AIRGAIN[®] SKYWIRE[®] NL-SW-LTE-TCTWWG

Product Change Notification - End of Life (EOL)

This PCN also introduces the NL-SW-LTE-TC1WWG-B Skywire modem, which is the recommended replacement:

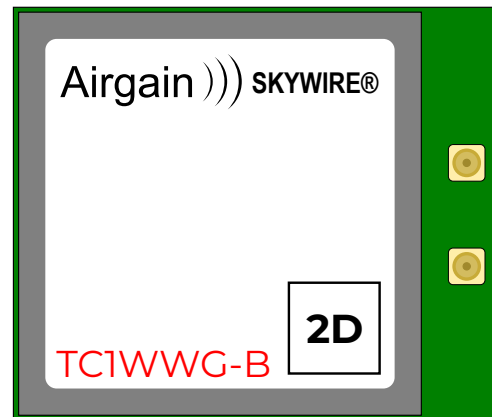
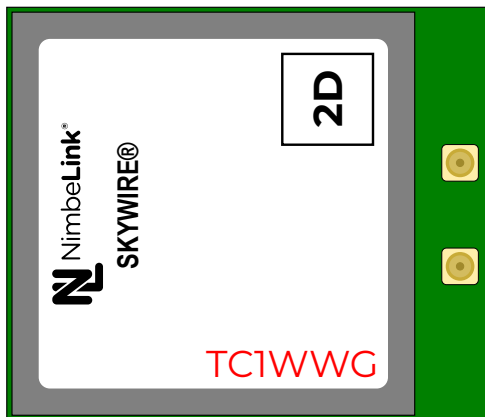
The NL-SW-LTE-TC1WWG-B label design has also been modified. The label has been rotated 90 degrees and the branding has been changed from NimbeLink to Airgain. This change is cosmetic and does not affect the label contents (IMEI, ICCID, etc.) or the barcode encoding.

If your manufacturing process includes visual inspection of Skywire modem labels and/or barcode scanning, Airgain recommends reviewing manufacturing work instructions and confirming that scanning equipment can accommodate the new orientation.
